**First Revision No. 39-NFPA 79-2019 [Global Input]**

Global FR for Reorganization of Chapter 5.

Figure 6.2.3 Jointed Test Finger.

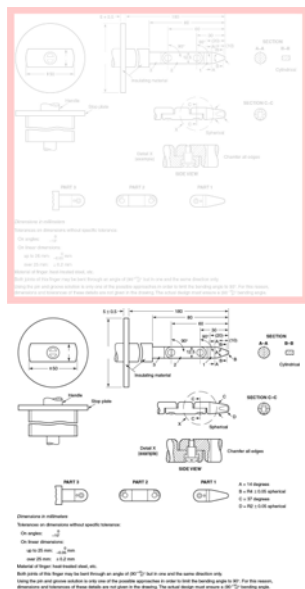
Figure 6.2.3: Figure 6.2.3 was revised to include critical dimensions needed to permit the probe to reproduced.

Figure A.4.5.2(a) Symbol that Represents Functional Equipotential Bonding — IEC Symbol Number 5020.

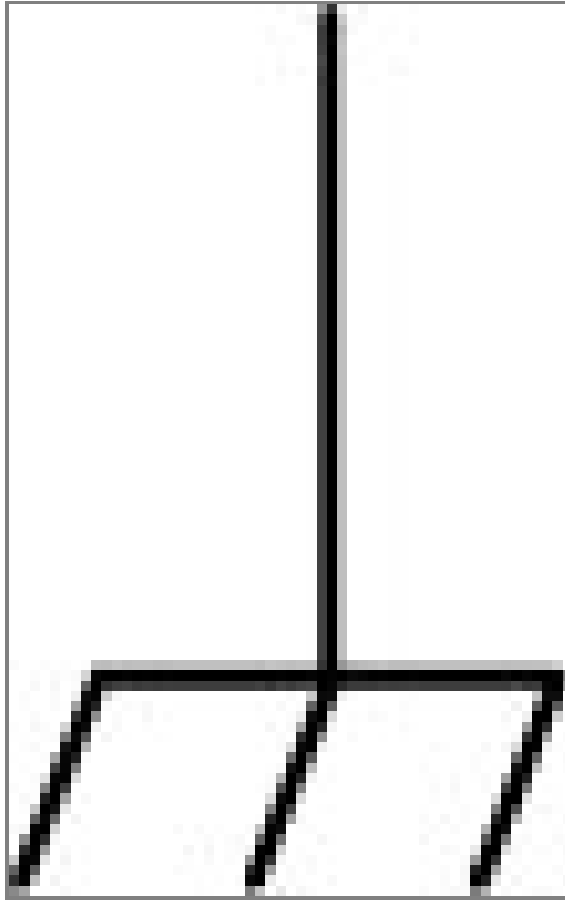
- (a) Connection of sensitive electrical circuits to the chassis. Such terminations should be marked or labeled with the IEC Symbol 5020 from IEC 60417-1. [See Figure A.4.5.2(a).]

Figure A.4.5.2(b) Symbol that Represents Functional Earthing — IEC Symbol Number 5018.

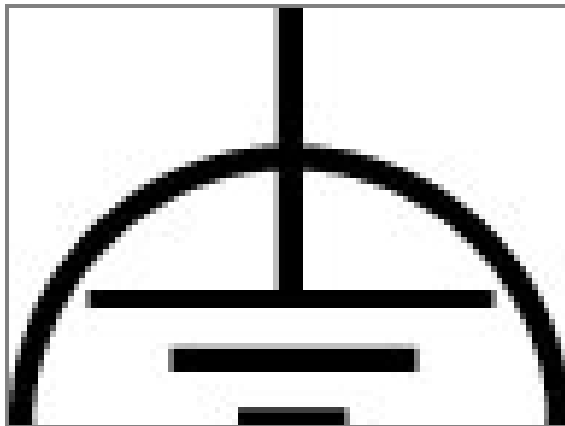
- (b) Connection of the chassis to earth (PE) using a conductor with low RF impedance and as short as practicable.
 - (c) Connection of sensitive electrical equipment or circuits directly to the PE circuit or to a functional earthing conductor (FE), to minimize common mode disturbance. This latter terminal should be marked or labeled with the IEC Symbol 5018 from IEC 60417. [See Figure A.4.5.2(b).]
